Re: Wander Village Plan 1 Amendment 2 (major)

Village Plan Amendment 2

Jordan Promenade (Wander) Village Plan 1

**AREA 1 VILLAGE PLAN
AMENDMENT 2**

SECTION 2 - DETAILED USE MAP

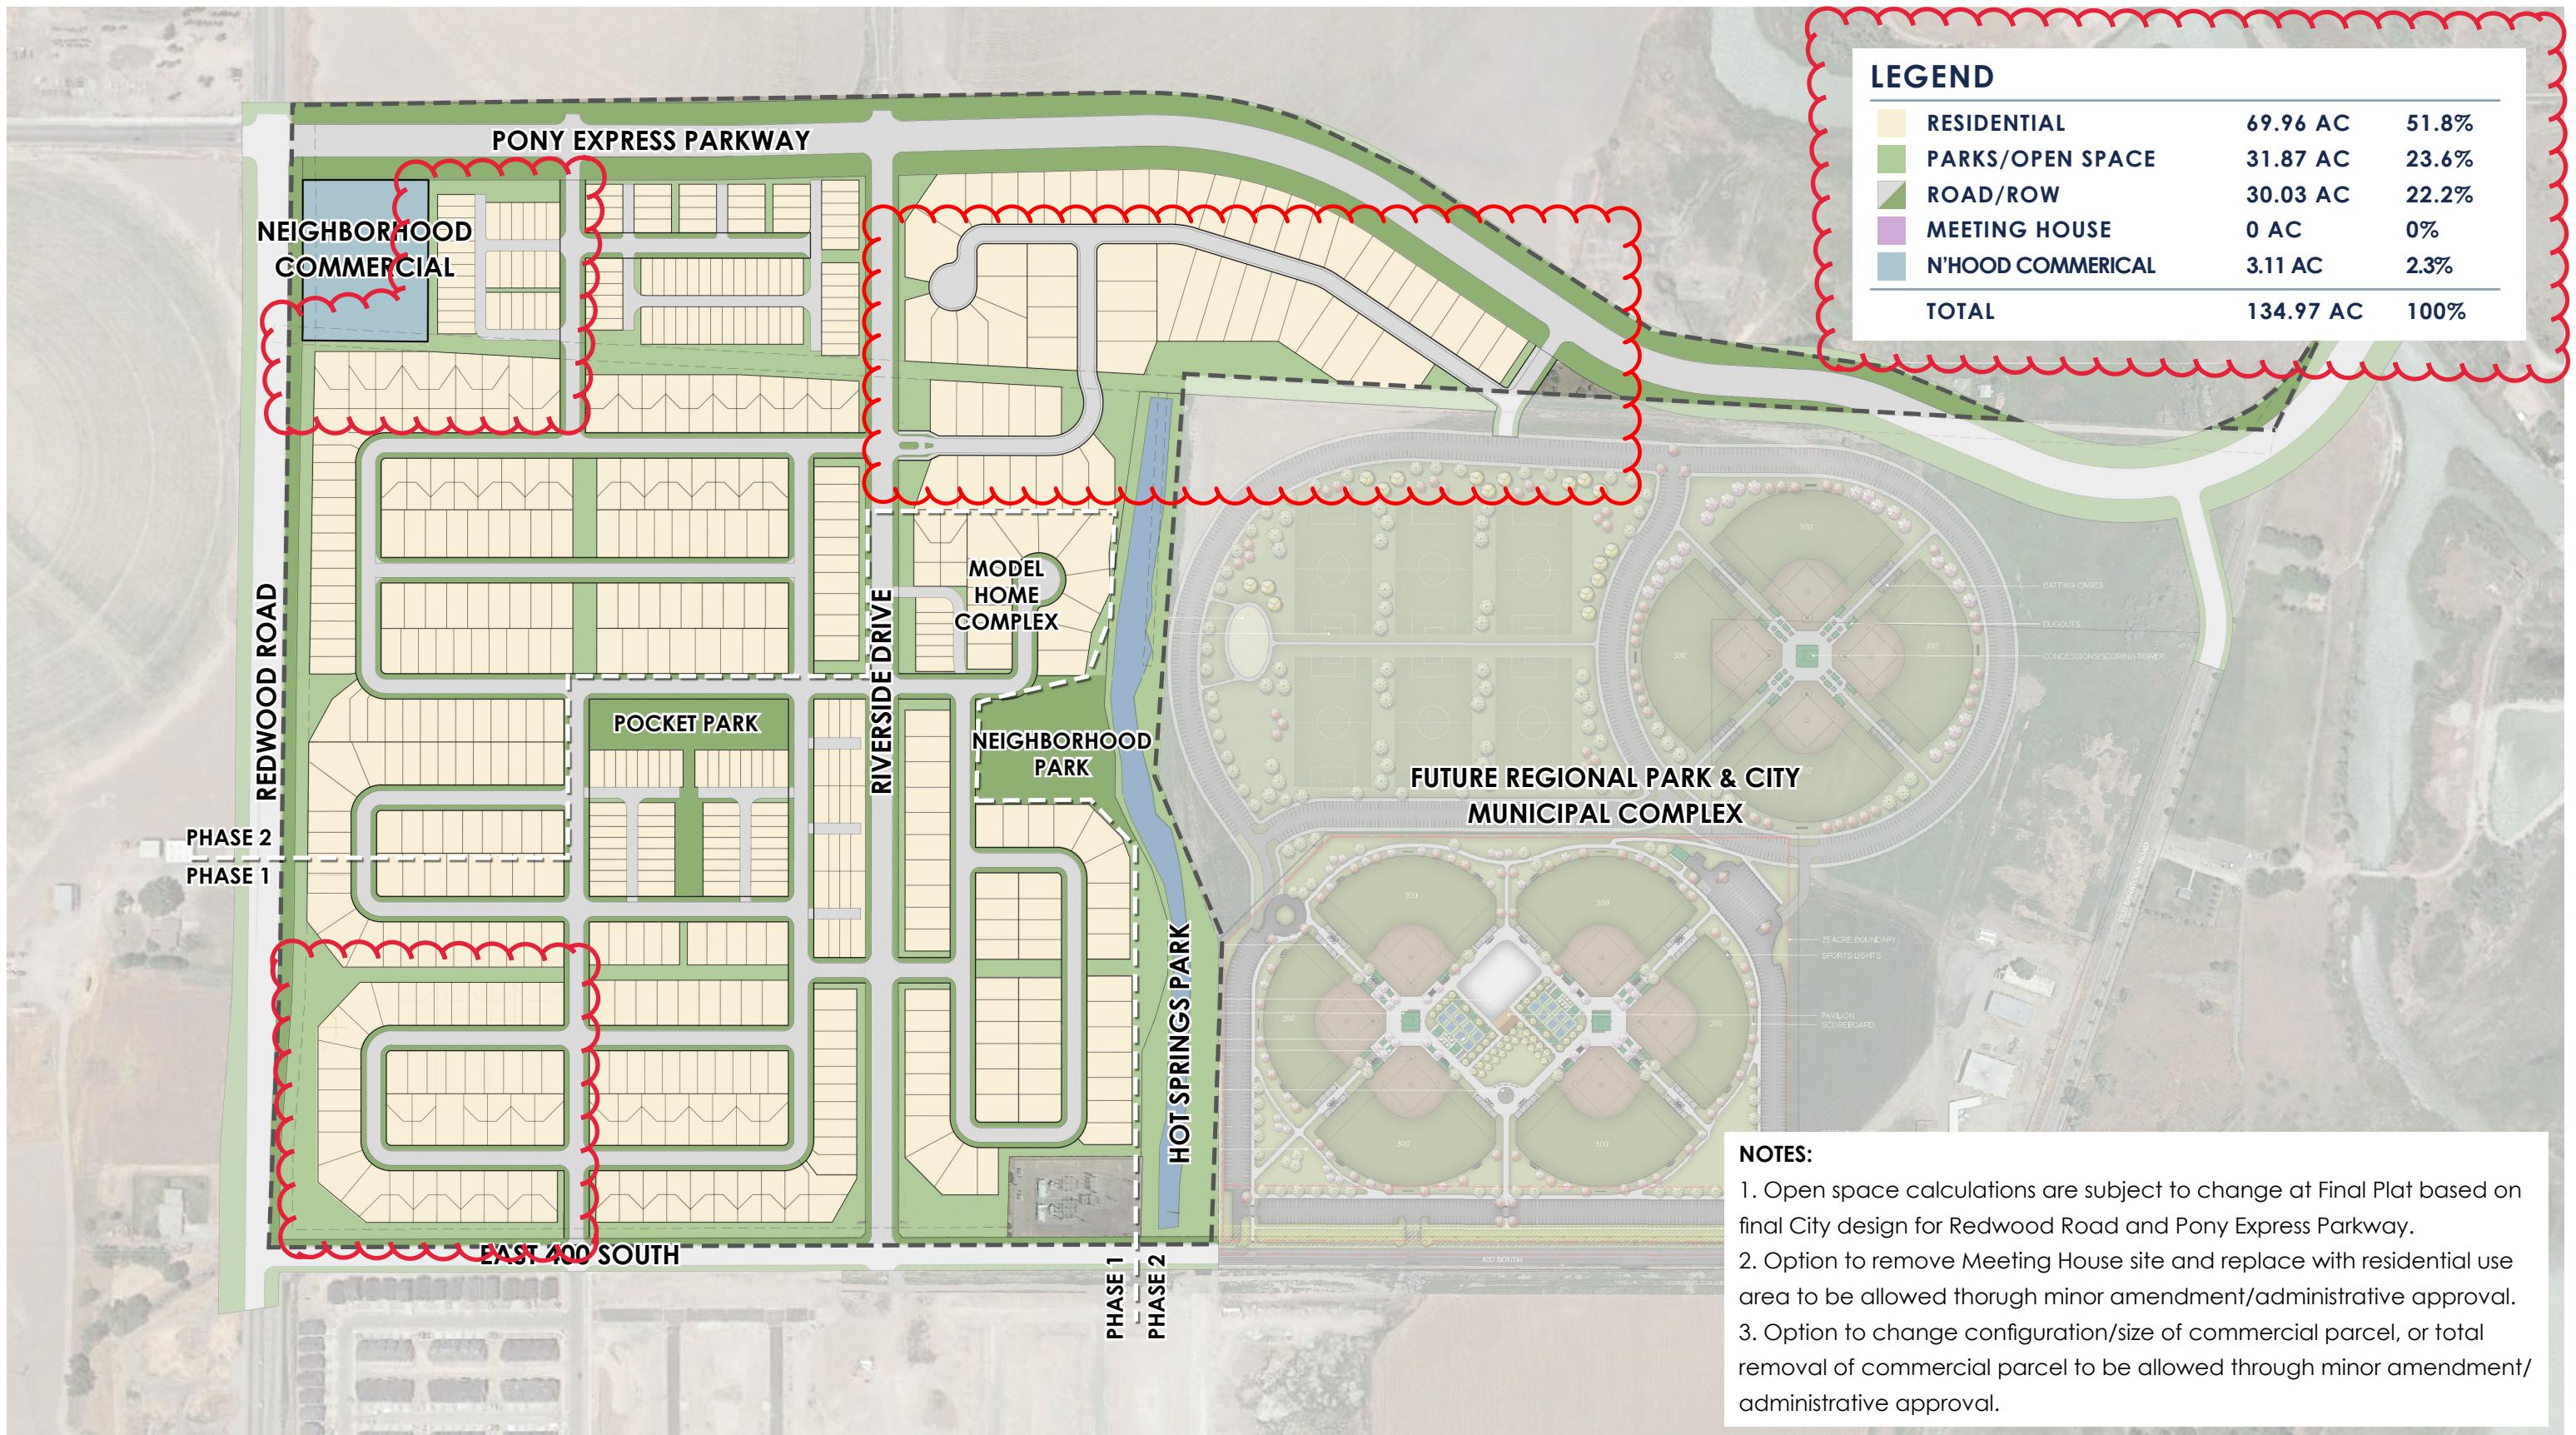
Page 8 & 9: Replace the road connection south of the Neighborhood Commercial to open space and trail, reducing the amount of open space from 33.04 acres to 31.87 acres. Reformatting the lotting plan near Neighborhood Commercial, the lots at the corner of Redwood Road and 400 South and increasing lot sizes in the neighborhood south of Pony Express and North of Patriot Park. Overall unit has increased by four units, however, the count is still within the range of approval.

SECTION 9a - OVERALL LANDSCAPE PLAN

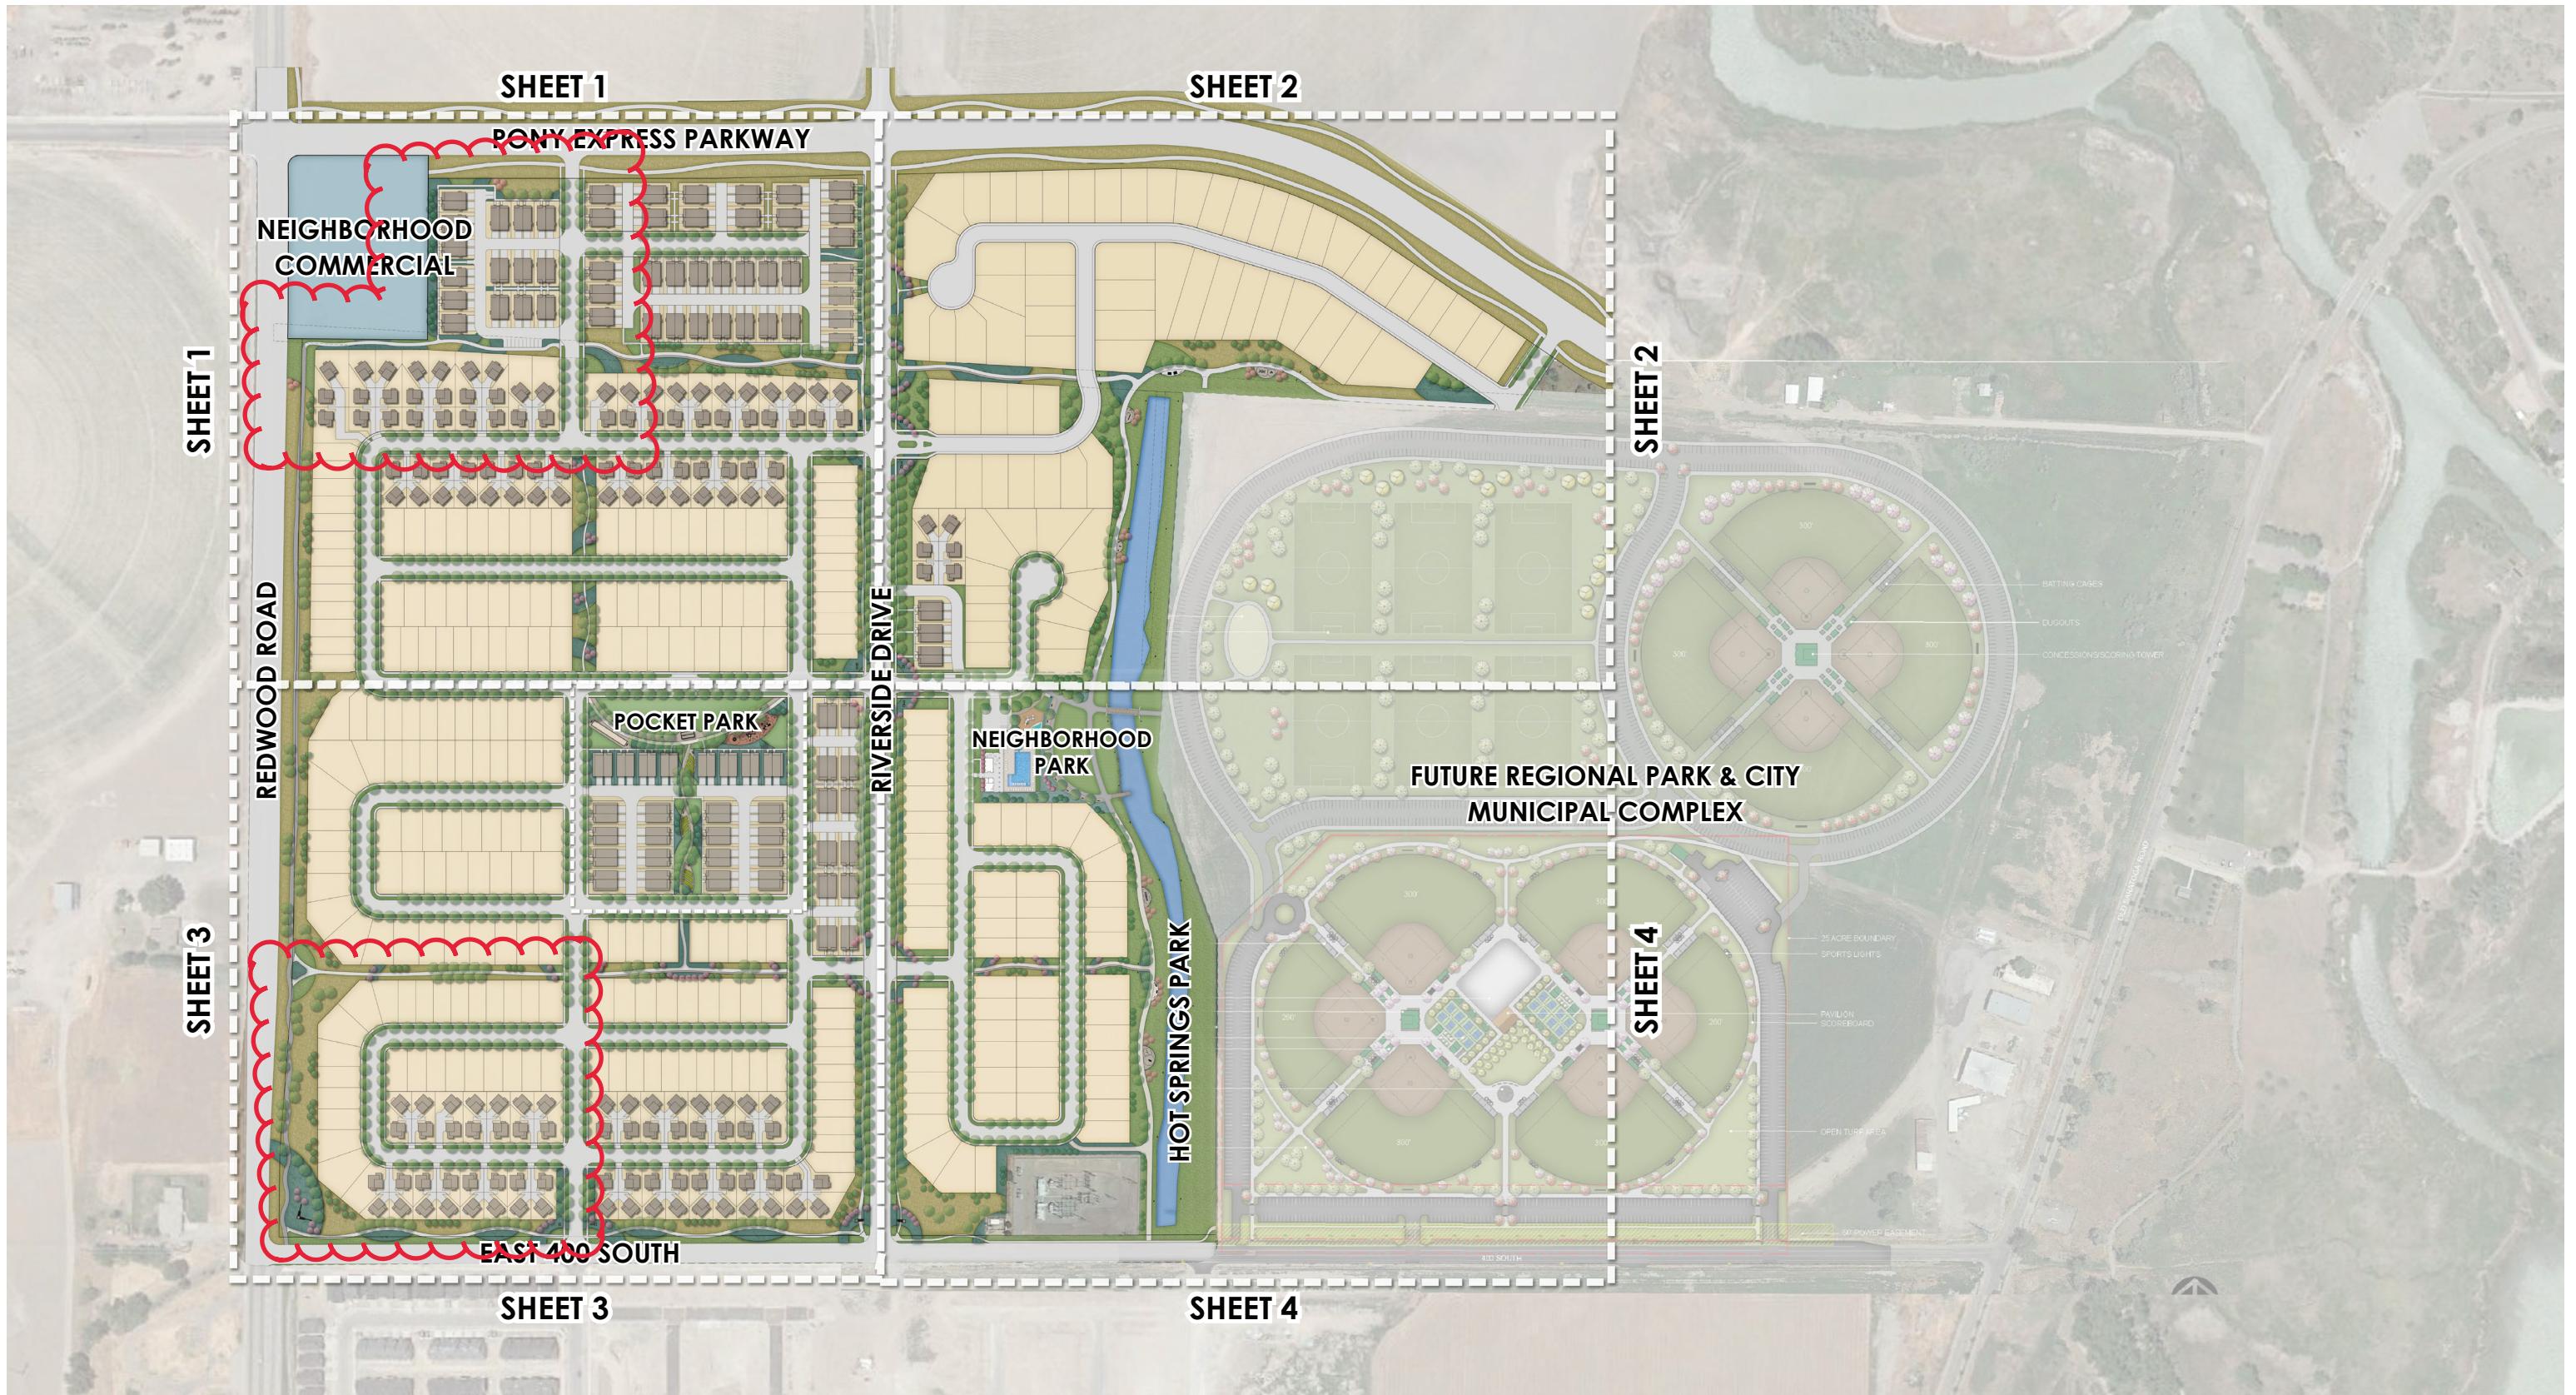
Pages 59, 60, 61: Updates the landscaping plan to reflect the lotting changes and the inclusion of open space and trail at the northwest of the Village Plan.

SECTION 11 - VEHICULAR PLAN

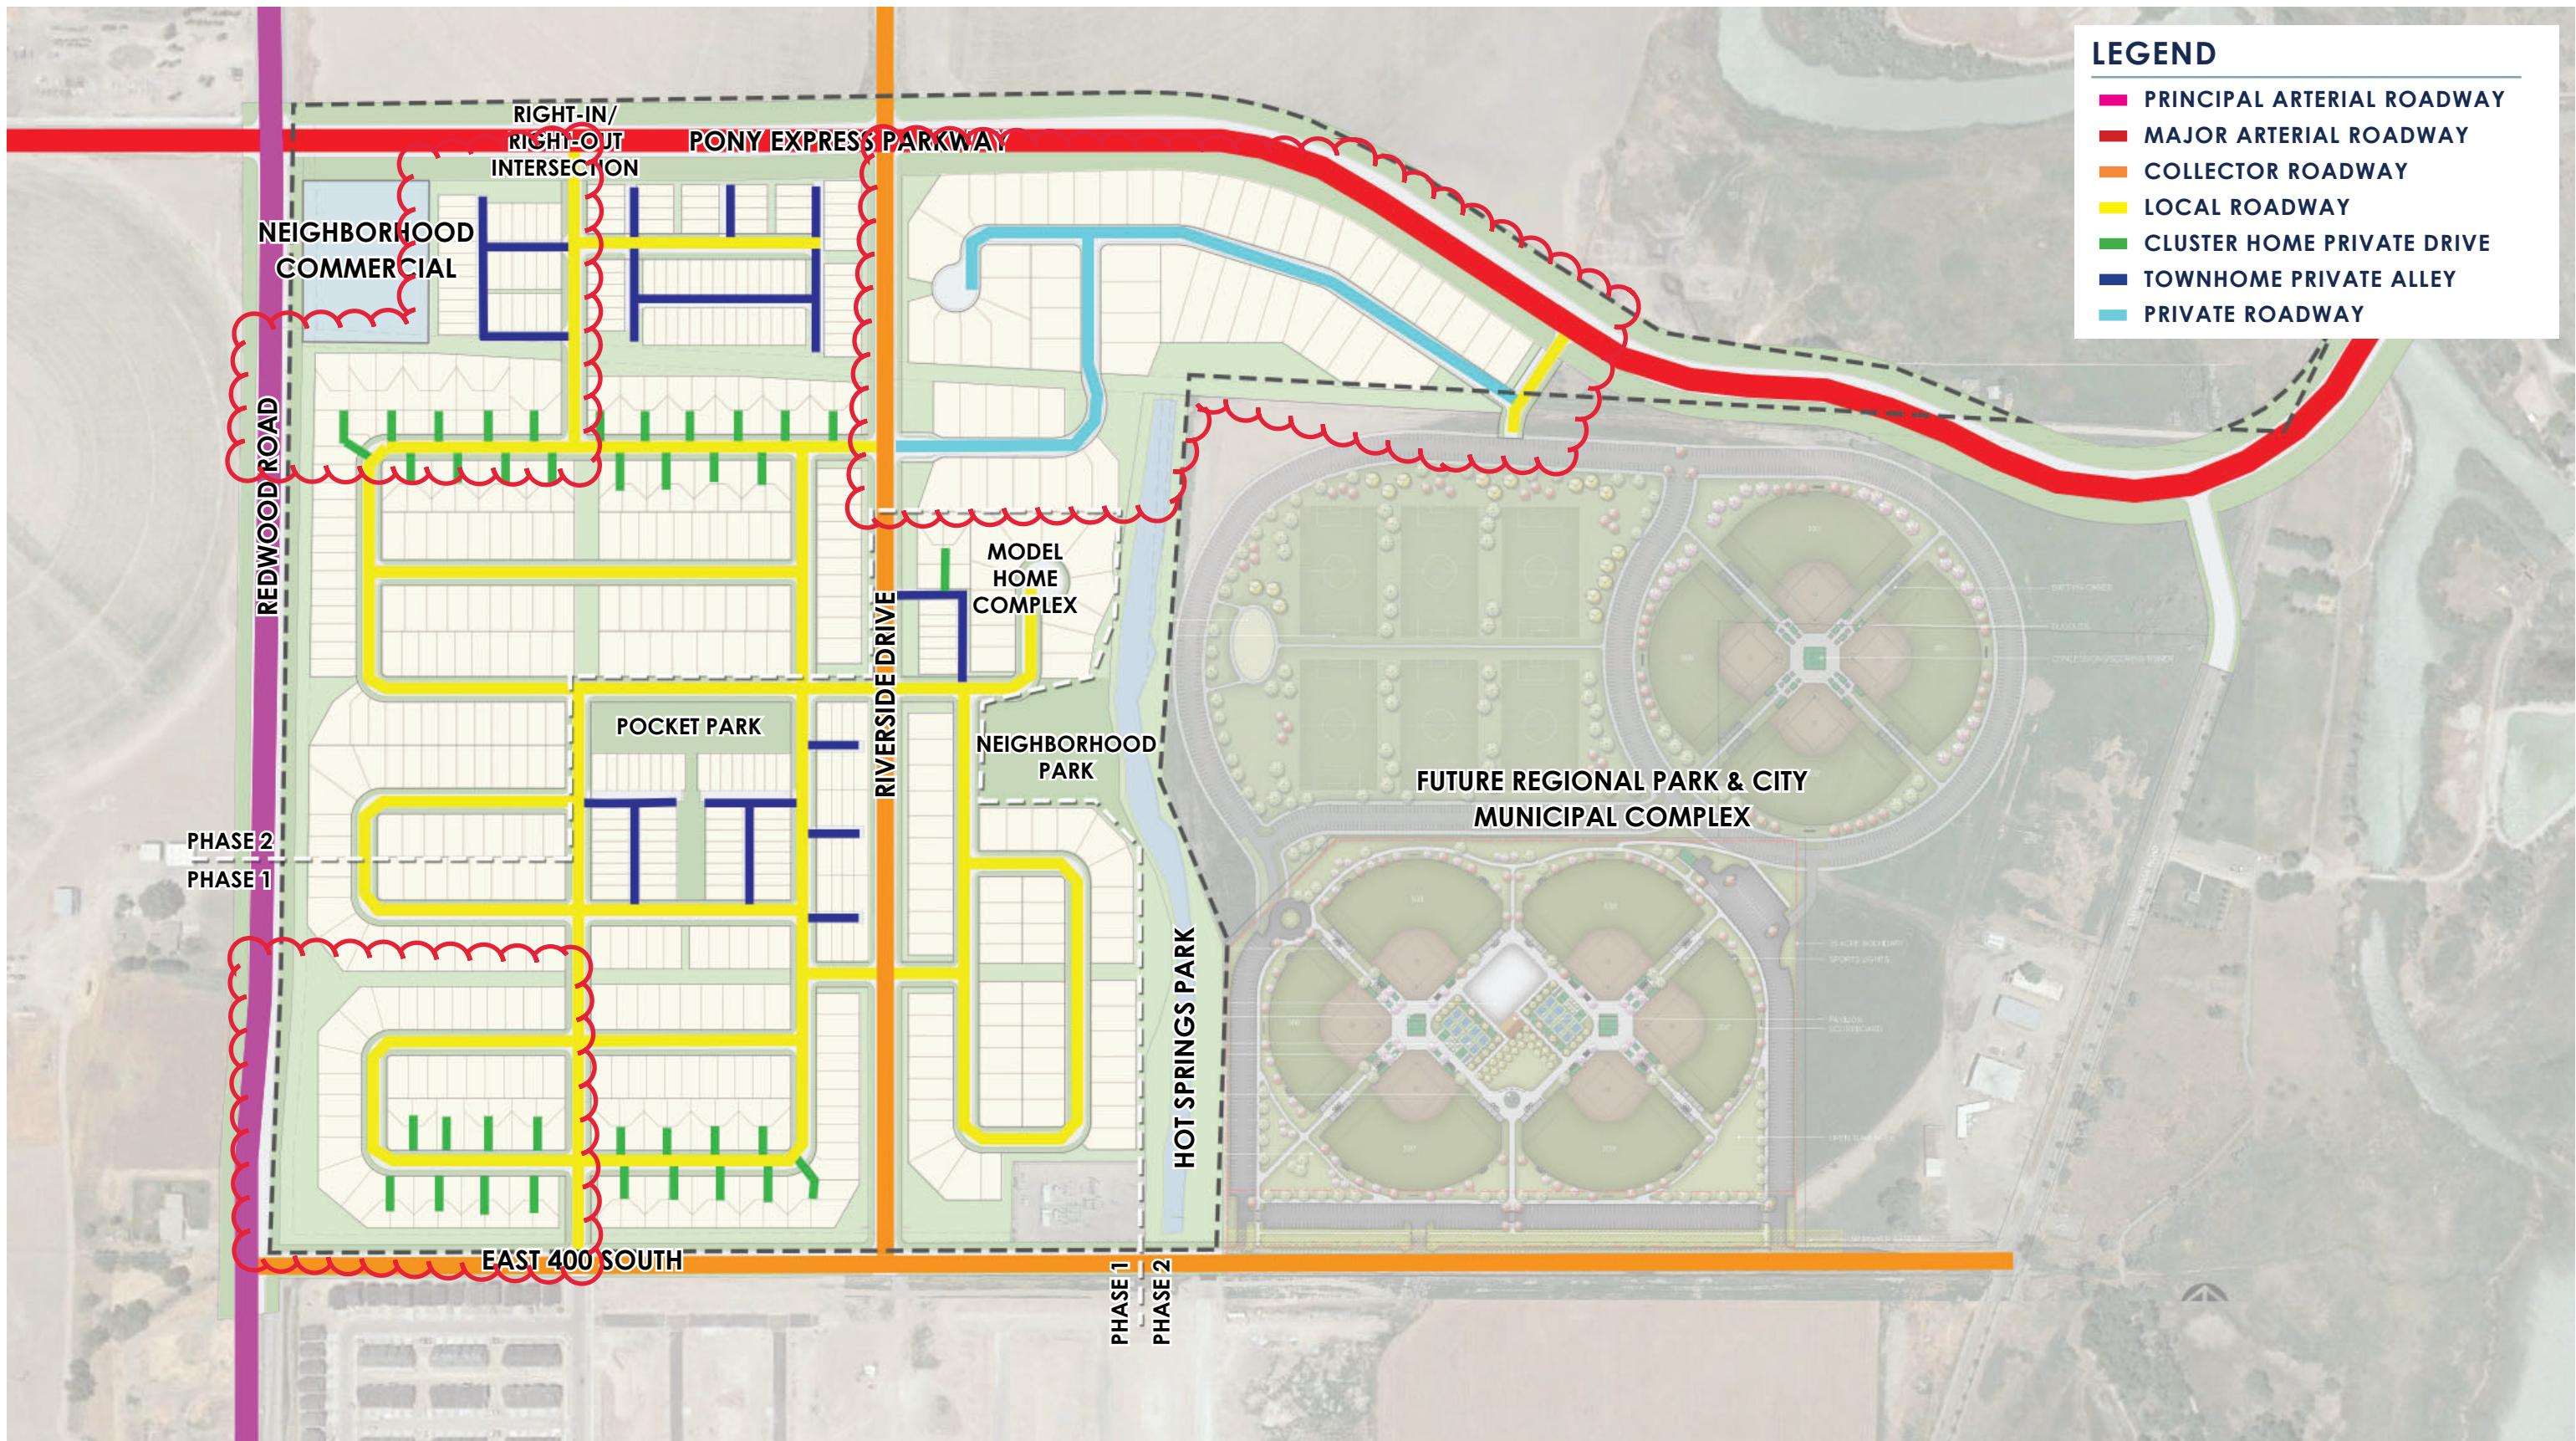
Page 81: Reflects changes to lotting plan and changes a local roadway to a private roadway.
